**BELLEVILLE COMBINED LICENSE APPLICATION – RESPONSE TO REQUEST FOR
ADDITIONAL INFORMATION – SHORT TERM ATMOSPHERIC DISPERSION ESTIMATES
FOR ACCIDENT RELEASES**

Reference: Letter from Joseph Sebrosky (NRC) to Andrea L. Sterdis (TVA), Request for
Additional Information Letter No. 119 Related to SRP Section 02.03.04 for the
Belleville Units 3 and 4 Combined License Application, dated August 08, 2008

Subject: Short Term Atmospheric Dispersion Estimates for Accident Releases in the Final Safety
Analysis Report

NRC RAI NUMBER: 02.03.04-05

Figure 02.03.04-05A

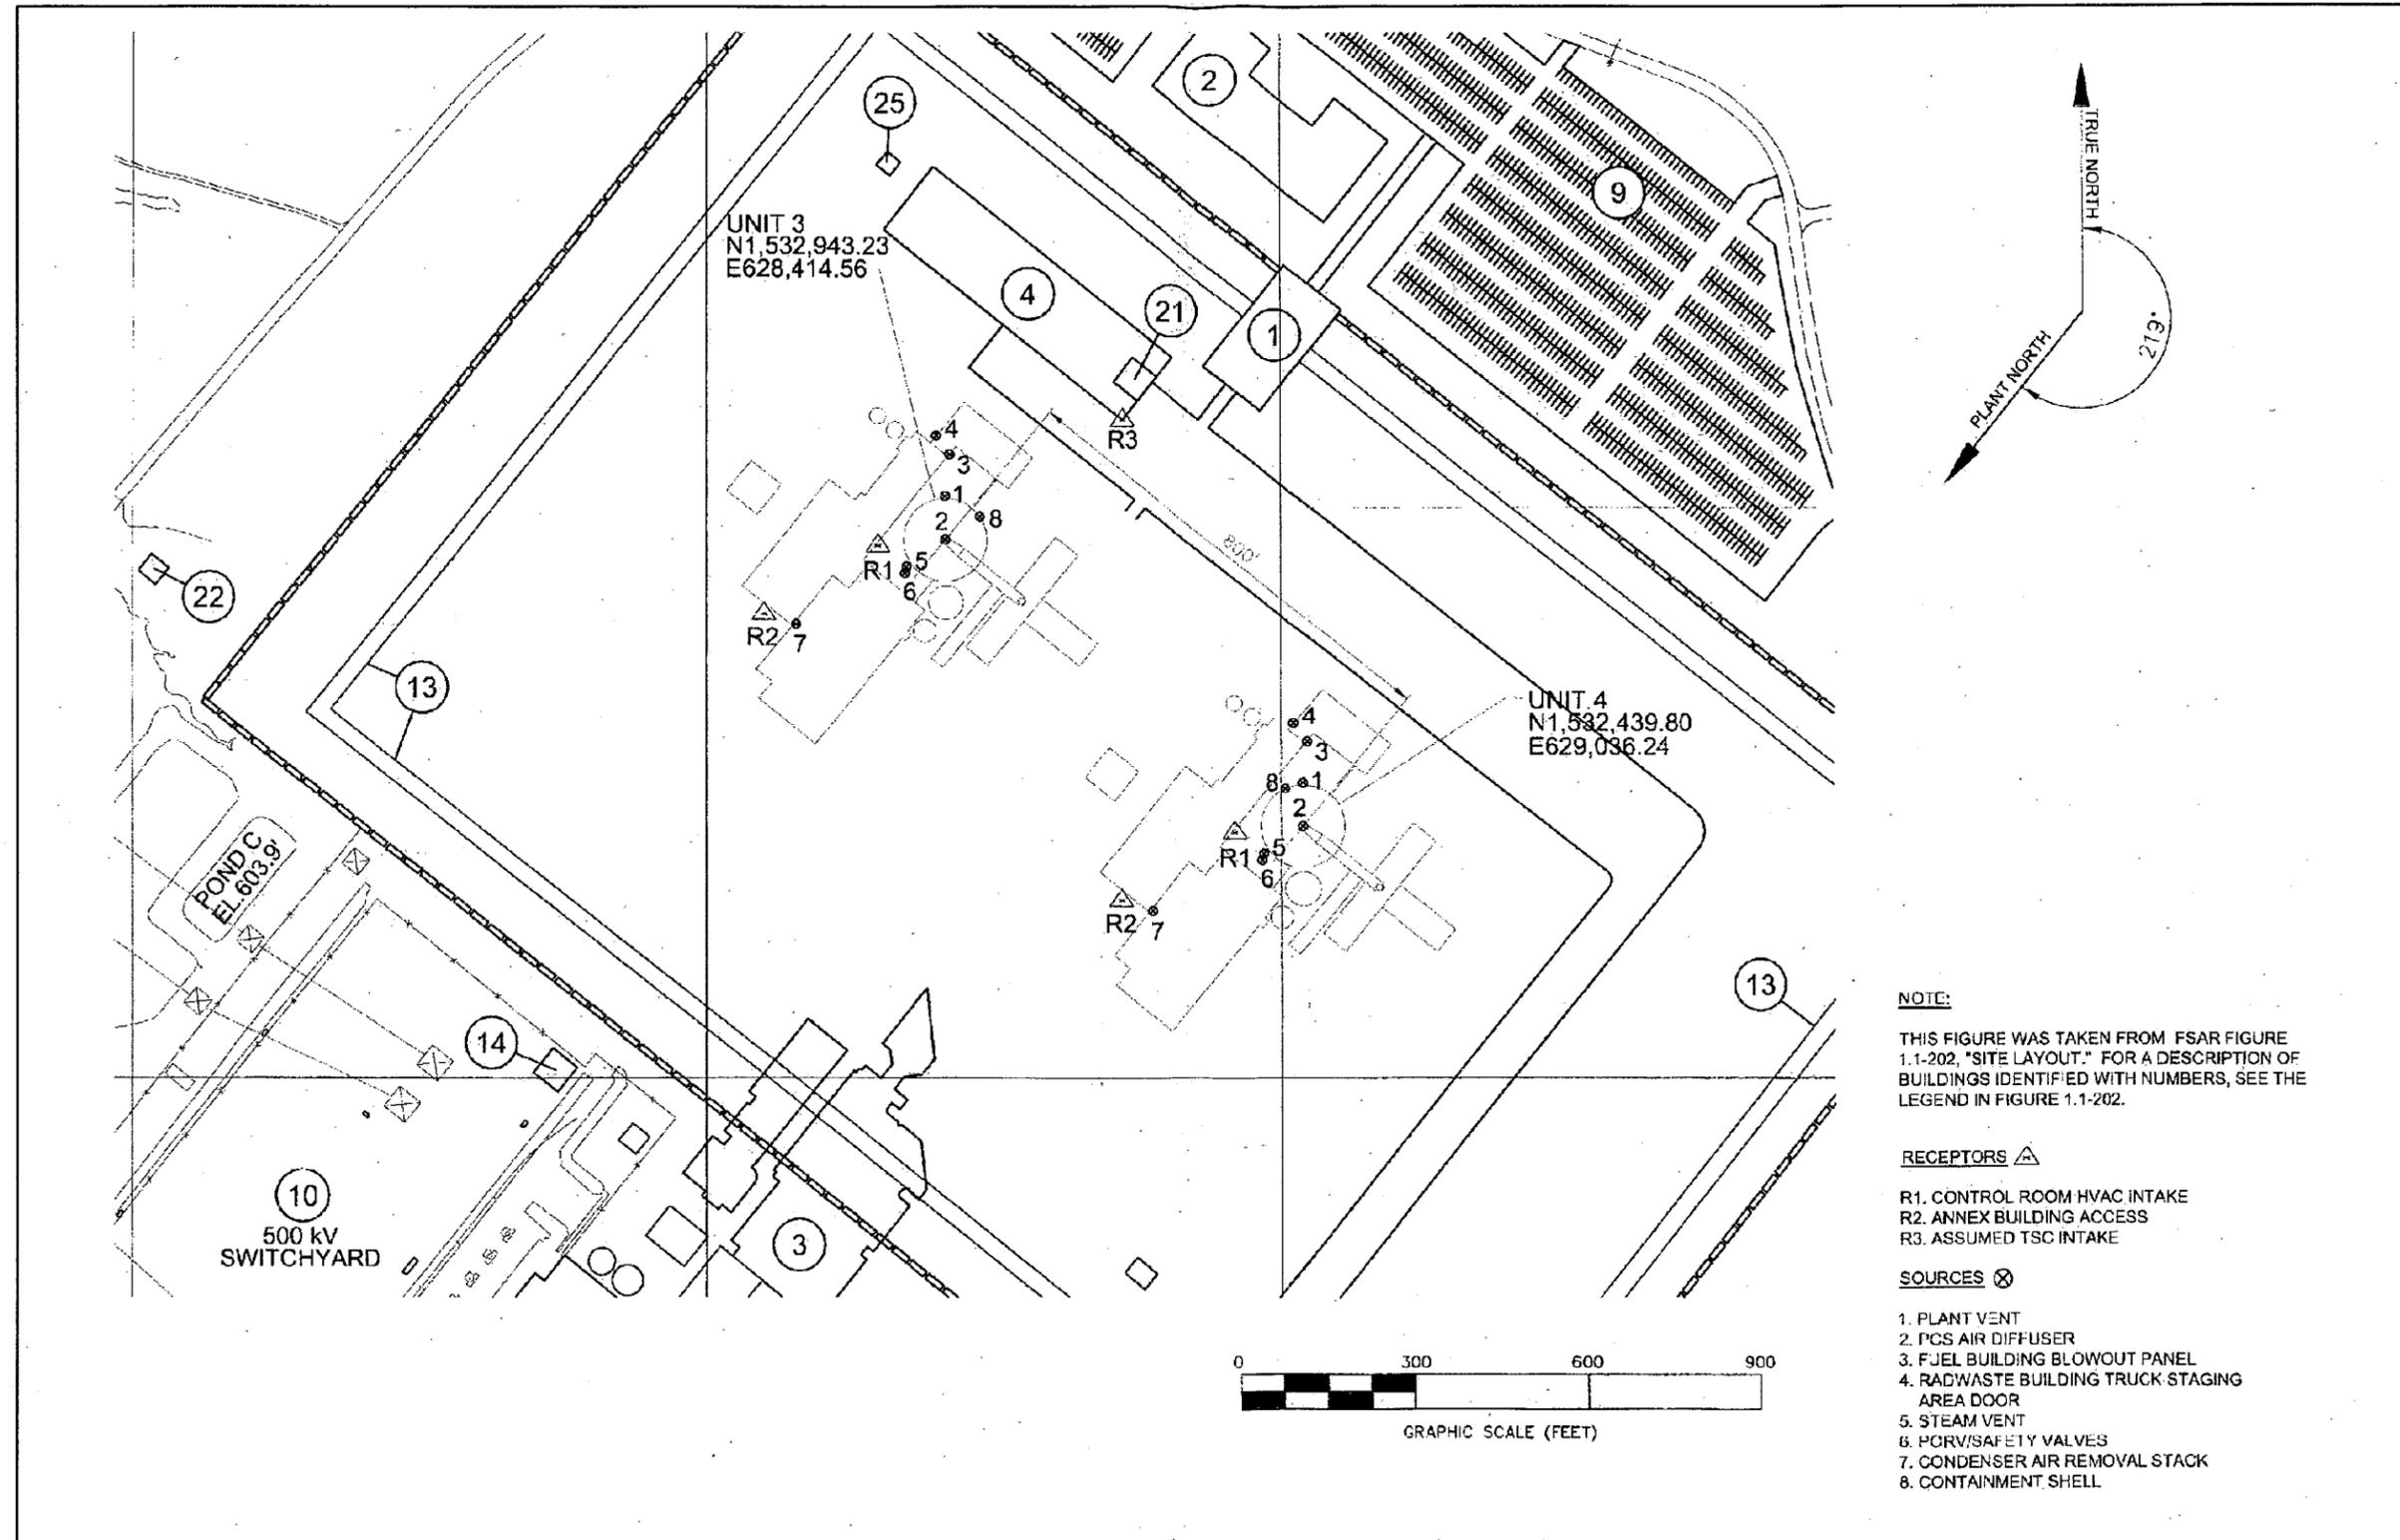
The applicant has taken a departure in FSAR Chapter 18, Human Factors Engineering, in that the Bellefonte TSC is not located in the control building as identified in the AP1000 DCD (Departure No. BNL DEP 18.8-1). Provide a description of the methodology, inputs, assumptions, and calculated atmospheric dispersion factors (χ/Q values) for releases from the Plant Vent, PCS Air Diffuser, Fuel Building Blowout Panel, Fuel Building Rail Bay Door, Steam Vent, PORV/Safety Valves, Condenser Air Removal Stack, and Containment Shell to the Technical Support Center (TSC). Information provided should be analogous to that provided for releases to the control room and include drawings to show relevant information graphically. Consider providing the computer input files as part of the response.

The TSC is located in the east end of the BLN maintenance building as shown in the Site Layout, FSAR Figure 1.1-202. Exact locations of the receptors of interest, the TSC HVAC intake and facility entrance, are not yet final; therefore, they are conservatively assumed to be located on the wall of the new maintenance building closest to Unit 3 at an elevation of 1.5 m (see Figure 02.03.04-05A below).

The AP1000 release locations are given on DCD Figure 15A-1 and Table 15A-7. When these locations are transposed onto the BLN Site Layout as shown in Figure 02.03.04-05A, it can be seen that the general direction from the assumed TSC receptors to the majority of the release locations is very similar. The release locations that are closest to the TSC are the containment shell, the plant vent, the fuel building blowout panel, and the radwaste building truck staging area door. According to the AP1000 DCD
